# UNITED STATES PATENT AND TRADEMARK OFFICE

APPLICATION NO.	FILING DATE	FIRST NAMED INVENTOR	ATTORNEY DOCKET NO.	CONFIRMATION NO.
08/851,465	05/05/1997	EDGAR C. ROBINSON	INT21246	5986
21118 7590 02/15/2012 JOHN RUSSELL UREN 2431 Simpson Road Richmond, BC V6X 2R2 CANADA				
EXAMINER				
SAVANI, AVINASH A				
ART UNIT		PAPER NUMBER		
3749				
MAIL DATE		DELIVERY MODE		
02/15/2012		PAPER

**Office Action Summary****Application No.**

## **DETAILED ACTION**

20. Segment of Fig. 1 of Nutten (the examiner has added the lead arrows and text appearing below).

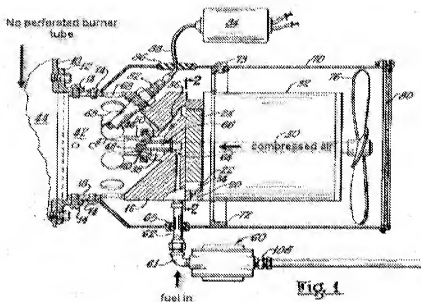
22. As discussed and above and illustrated in the segments of applicant's Fig. 5A and Nutten's Fig. 1, Nutten discloses all the elements of applicant's claim 1 with the exception of a burner tube with a perforated outer surface rendering the burner an "infrared burner." However, the examiner has pointed to Patrick showing the use of a perforated burner tube in the burner art forming an "infrared burner." The following is a segment of Fig. 7 of Patrick which is disclosed as being an infrared liquid fuel burner (next page):

21. Rotated Copy of Applicant's Fig. 5A (the examiner has added the lead arrow and "perforated burner tube" text appearing below).

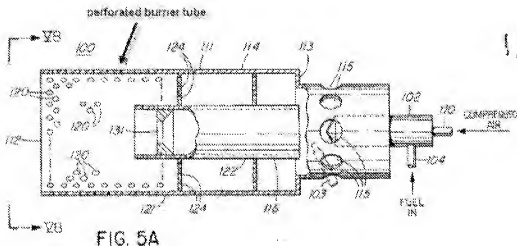
5. As discussed above, claim 1 has been amended to include the recitation of perforations which are located "immediately adjacent" the nozzle. However, it is unclear from the claim if the perforations are intended to be the openings shown in the sides of the burner tube (120), the perforations in spacer plates (124), or the perforations supplying air to the nozzle (115).

6. For Examination purposes, the examiner has regarded the claims as referring to the perforations in the sidewalls of the burner tube (120), but applicant is requested to clarify if the claim is intended to read on the perforations in the sideways spacing plates (124) or at the nozzle outlet (115).

23. Segment of Fig. 7 of Patrick (the examiner has added the lead arrow and text appearing below).

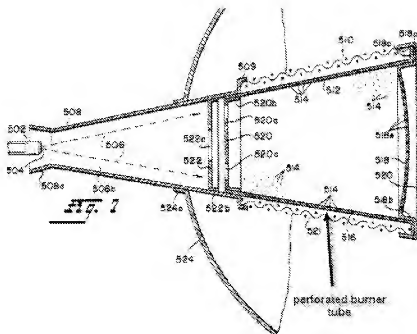
24. As seen in the above Figures, and noted in the above 112 rejections, the scope of the new claim limitation that the burner tube has perforations extending immediately adjacent the nozzle is unclear. However, Patrick is regarded to teach this limitation, as Patrick shows a liquid fuel nozzle (502) upstream of a perforated burner tube (514). To the extent the perforated burner tube of applicant is "immediately adjacent" the fuel nozzle, the Patrick burner tube is regarded as being "immediately adjacent" to the nozzle, as they show the same configuration.
